**GM SERVICE AND PARTS OPERATIONS**  
**DCS1667**  
**URGENT - DISTRIBUTE IMMEDIATELY**

Subject: Product Safety Recall 06080A  
Fuel Rail Pulse Damper Retainer Clip  
Service Procedure Revised

Models: 2004-2006 Chevrolet Avalanche, Silverado, Suburban  
2004-2006 GMC Sierra, Yukon XL  
2006 Chevrolet Kodiak  
2006 GMC TopKick  
Equipped with 8.1 L Engine (RPO L18 – VIN G)

**SUBJECT: FUEL RAIL PULSE DAMPER RETAINER CLIP**

SIO 1254422

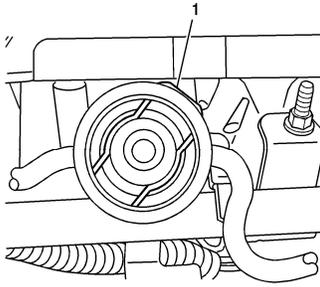
**CAUTION:** If the fuel pressure is not relieved as instructed in step 8, or the dampener is not held in position during the replacement of the dampener clip, the dampener O-ring may not seat or seal properly. A damaged or improperly seated O-ring may result in a fuel leak. A fuel leak in the presence of an ignition source may result in a fire.

**CAUTION:** Do not remove the fuel dampener from the fuel rail. If the dampener is removed, a fuel dampener kit with a new O-ring must be installed. If the dampener and O-ring is not replaced, a fuel leak may result. Clean dirt and/or debris from dampener cavity and lubricate the new O-ring with clean engine oil prior to installation of the dampener.

**NOTICE:** Push down on the fuel dampener until steps 16 and 17 are completed to avoid damaging the dampener O-ring.

16. Push down on the fuel dampener and remove the fuel pressure dampener clip (1). Discard old dampener clip.

SIO 1254422

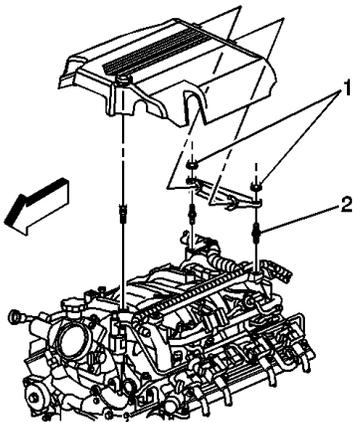
17. Push down on the fuel dampener and install the new fuel pressure dampener clip (1).
18. Install the fuel fill cap.
19. Connect the negative battery cable. Refer to Battery Negative Cable Disconnection and Connection in SI.
20. Use the following procedure to inspect for leaks:
  - 20.1 Turn the ignition ON, with the engine OFF, for 2 seconds.
  - 20.2 Turn the ignition OFF for 10 seconds.
  - 20.3 Turn the ignition ON, with the engine OFF.
  - 20.4 Inspect the fuel rail, fuel rail dampener, and fuel rail pressure cap and valve for fuel leaks.

If a leak is present, a dampener kit with new O-ring must be installed. Relieve the system pressure as described in steps 4-14 above. Clean dirt and/or debris from dampener cavity and lubricate the new O-ring with clean engine oil prior to installation of the dampener. When finished, repeat steps 20.1-20.4.

SIO 1254422

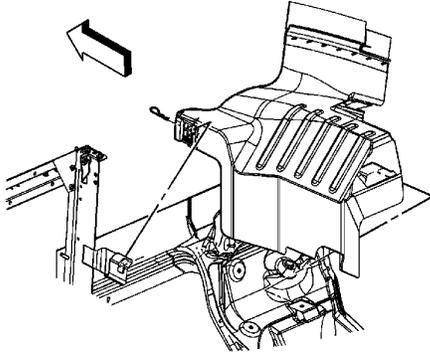
- CAUTION:** If the fuel pressure is not relieved as instructed in steps 7-9, or the dampener is not held in position during the replacement of the dampener clip, the dampener O-ring may not seat or seal properly. A damaged or improperly seated O-ring may result in a fuel leak. A fuel leak in the presence of an ignition source may result in a fire.
- CAUTION:** Do not remove the fuel dampener from the fuel rail. If the dampener is removed, a fuel dampener kit with new O-ring must be installed. If the dampener and O-ring is not replaced, a fuel leak may result. Clean dirt and/or debris from dampener cavity and lubricate the new O-ring with clean engine oil prior to installation of the dampener.
- NOTICE:** Push down on the fuel dampener until steps 11 and 12 are completed to avoid damaging the dampener O-ring.

11. Push down on the fuel dampener and remove the fuel pressure dampener retainer (1). Discard old dampener retainer.
12. Push down on the fuel dampener and install a new fuel pressure dampener retainer (1).
13. Install the 20A/25A ECM-B/FUEL PUMP fuse.
  - 13.1 Turn ON the ignition for 2 seconds.
  - 13.2 Turn OFF the ignition for 10 seconds.
  - 13.3 Turn ON the ignition.
  - 13.4 Inspect the fuel rail and fuel rail dampener for leaks. If a leak is present, a dampener kit with new O-ring must be installed. Relieve the system pressure as described in steps 7-9 above. Clean dirt and/or debris from

dampener cavity and lubricate the new O-ring with clean engine oil prior to installation of the dampener. When finished, repeat steps 13-13.4.
